Access Compliance Report

Public Rights-of-Way

(Curb Ramps)

Intersection ID: 14710	Main Street: LYNDHURST_AV	Cross Street: MCDONALD_AV	Location: E
ADA ID: 55255DAE2273	Ramp Type: Directional1	Initial Pass/Fail: Fail	Overall Compliance: No
Severity Score: 1.25			
Codes/Mitigation Info/Possible Solution		Field Measurements/Component Compliance

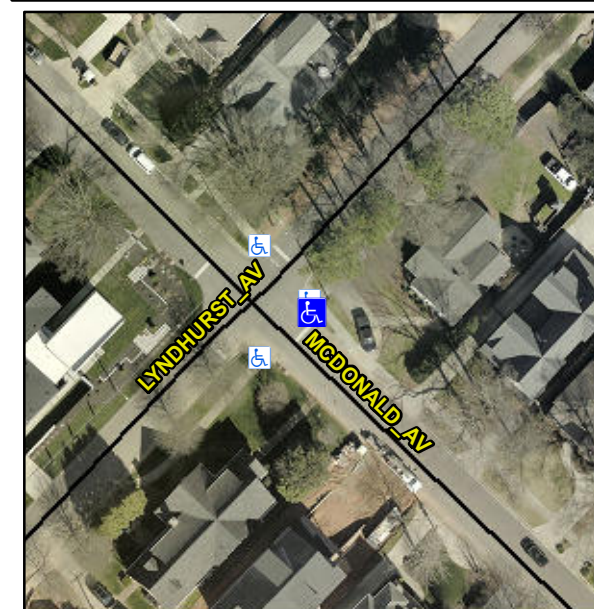
R304.5.3

Compliance	Description	Data	Compliance	Description	Data
N/A	Ramp Length (in)	106.0	N/A	Grade Break?	N/A
Yes	Ramp Width (in)	57.0	N/A	Grade Break Slope (%)	0.0
Yes	Ramp Slope (%)	6.9	N/A	Grade Break XSlope (%)	0.0
No	Ramp XSlope (%)	4.1			
N/A	Flare Type LT	N/A	N/A	Flare Type RT	N/A
N/A	Flare Slope LT (%)	N/A	N/A	Flare Slope RT (%)	0.0
N/A	Flare Traversable LT?	N/A	N/A	Flare Traversable RT?	N/A
N/A	Landing Length (in)	0.0	N/A	DWS Provided?	N/A
N/A	Landing Width (in)	0.0	N/A	DWS Contrast?	N/A
N/A	Landing Slope (%)	0.0	N/A	DWS Length (in)	N/A
N/A	Landing X Slope (%)	0.0	N/A	DWS Full Width?	N/A
N/A	Landing Curb? (Y/N)	N/A	N/A	DWS Offset LT (in)	N/A
N/A	Shared Landing?	N/A	N/A	DWS Offset RT (in)	N/A
N/A	Gutter Ponding?	0.0	N/A	Gutter Slope (%)	N/A
N/A	Gutter Lip Ht (in)	1.0	N/A	Gutter X Slope (%)	N/A
N/A	Painted X Walk1?	No		Road Slope (%)	5.1
	X Walk 1 Direction	To SW		Road X Slope (%)	0.2
	X Walk 1 Width (in)	N/A		Clear Space?	N/A

Remove & Replace Entire Ramp.
